## ADDENDUM NO. 2

### San Antonio Water System

Project Name: **LIFT STATIONS REHABILITATION – PHASE 2**

Project No.: **06-2503**

NOTES	INITIALS	DATE
DESIGNED BY	BLH	9/17/2010
REVIEWED BY	JRS	9/17/2010
SCALE:	AS SHOWN	
SHEET NO.	<b>E-223-3</b> 136 OF 246

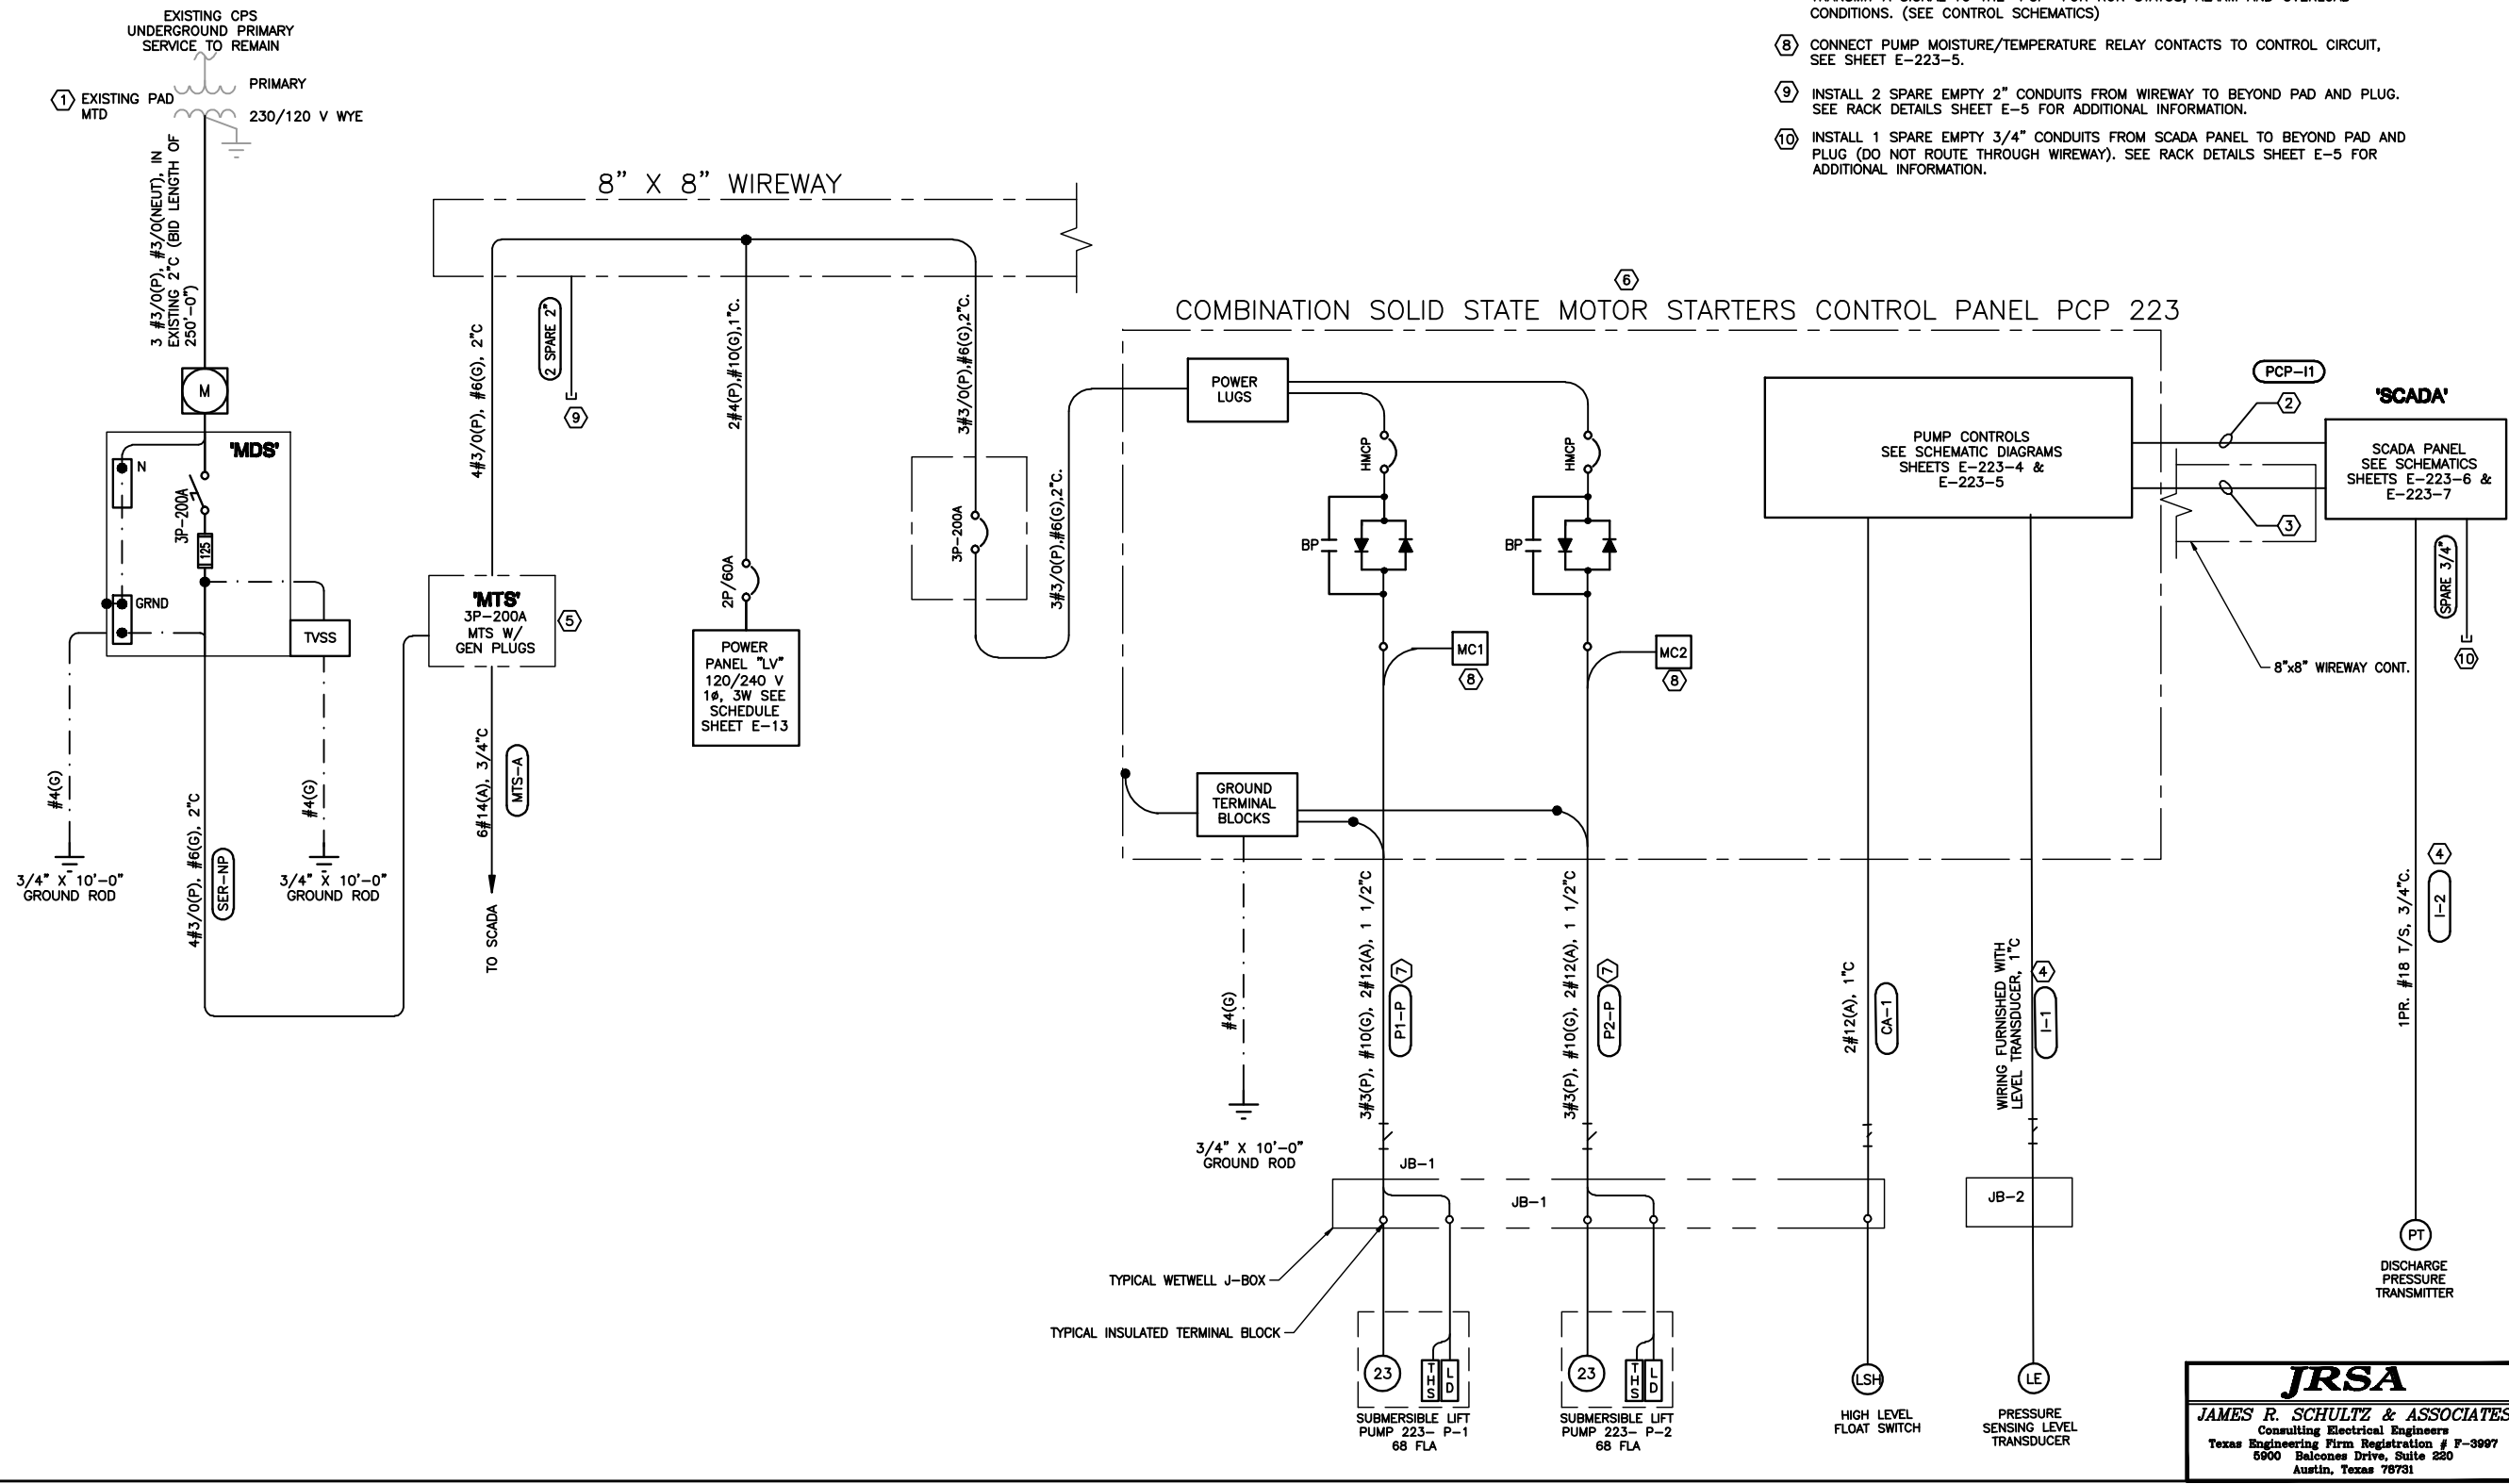
### **Item 3: LS# 223: Electrical Site Plan and One Line Diagram**

- a) Clarification: Drawing has been revised for combined Soft Start-PCP cabinet location and other electrical revisions, including service voltage change.
- b) DELETE Sheet E-223-1, Sheet 134 of 246 and REPLACE with attached revised sheet dated 10/21/2010.
- c) DELETE Sheet E-223-2, Sheet 135 of 246 and REPLACE with attached revised sheet dated 10/21/2010.
- d) DELETE Sheet E-223-3, Sheet 136 of 246 and REPLACE with attached revised sheet dated 10/21/2010.
- e) DELETE Sheet E-223-4, Sheet 137 of 246 and REPLACE with attached revised sheet dated 10/21/2010.
- f) DELETE Sheet E-223-8, Sheet 141 of 246 and REPLACE with attached revised sheet dated 10/21/2010.

SHEET NO. **E-223-8**  
141 OF 246

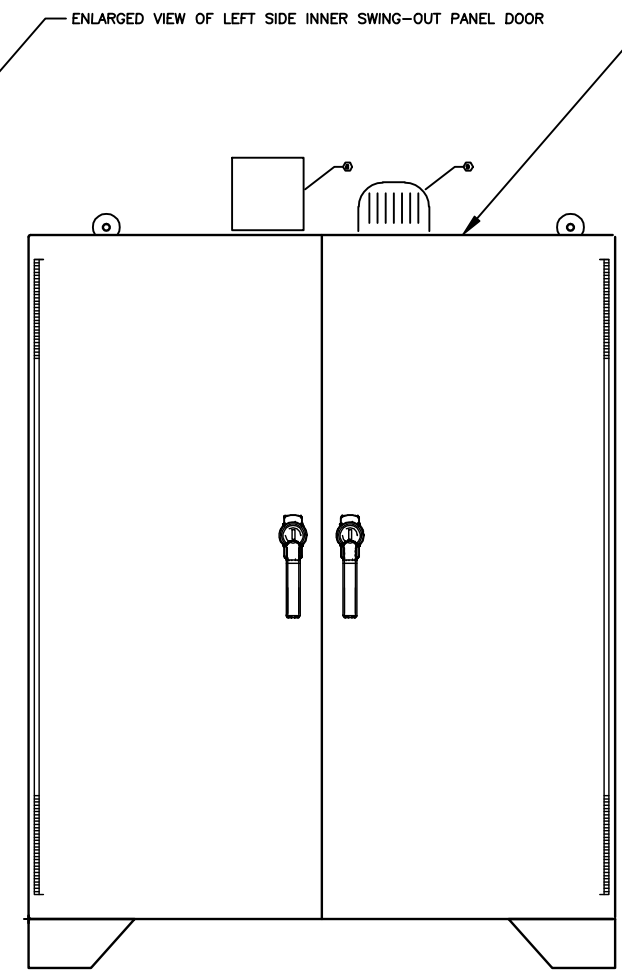
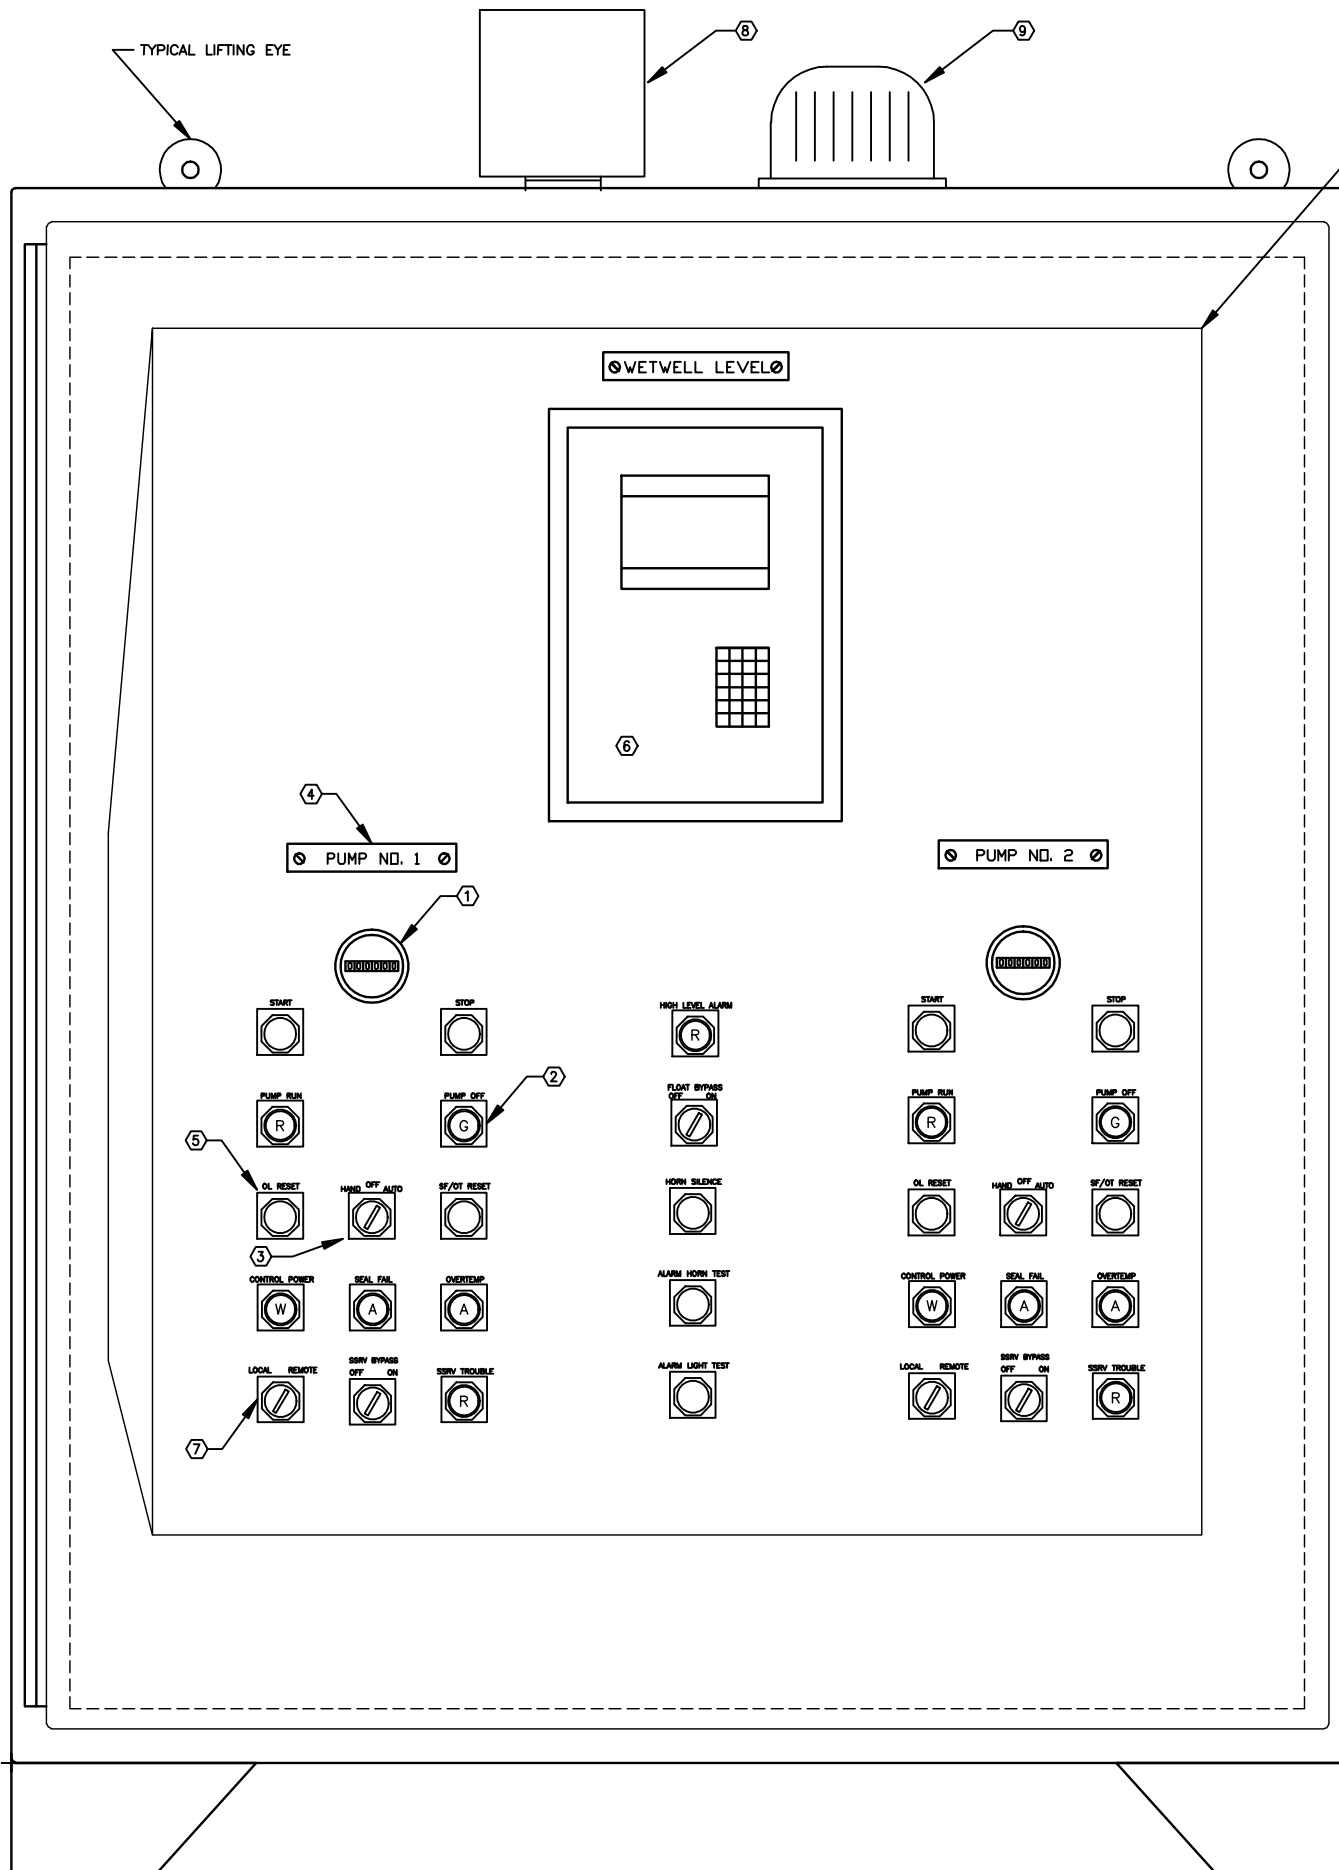
**Q32: Panels 223 and 238 have new Benshaw soft starters in separate enclosures. We often put the soft starters in the same enclosure as the main controls. Is this a possibility for these two panels?**

*Yes, except LS #192 shall remain same as currently shown, due to it is existing and in the floodplain. For LS #192, provide Hoffman NEMA 4X 316 Stainless Steel 62" x 48" x 12" free standing enclosure and combine both the control panel and soft starters into one enclosure, in lieu of 2 separate enclosures as currently specified and shown on drawings. For LS #238, locate combined Soft Start-PCP enclosure in same location as existing autodialer and PCP cabinets; re-direct respective conduits to this combined location. This may similarly apply to plan sheets E-223-1, E-223-3, E-223-4, E-238-1 & E-238-4. Note, Addendum No. 2 also addresses Q32 – see Item 3 and Item 4, B. Drawing Revisions for more details.*
